Credit Procedure: Reimbursement of Oil Pump Replacement

Bulletin number M1450 must be entered into the comments section of the claim.

Figure 1. Cam Support Plate Dowel Pin Measurement

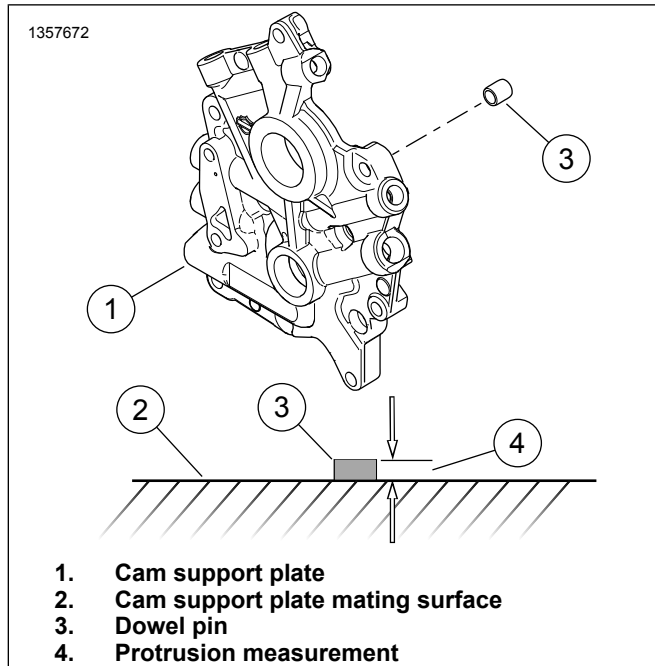
- j. See Figure 1. Verify that the protrusion (4) of the dowel pin (3) on the cam support plate (1) is equal to or less than 3.3 mm (0.130 in).

If engine damage is not observed: Install **new** oil pump and oil pump cover (Refer to Table 2.) then assemble engine and file the appropriate warranty claim. Refer to the applicable table, Table 3, Table 4, Table 5 or Table 6.
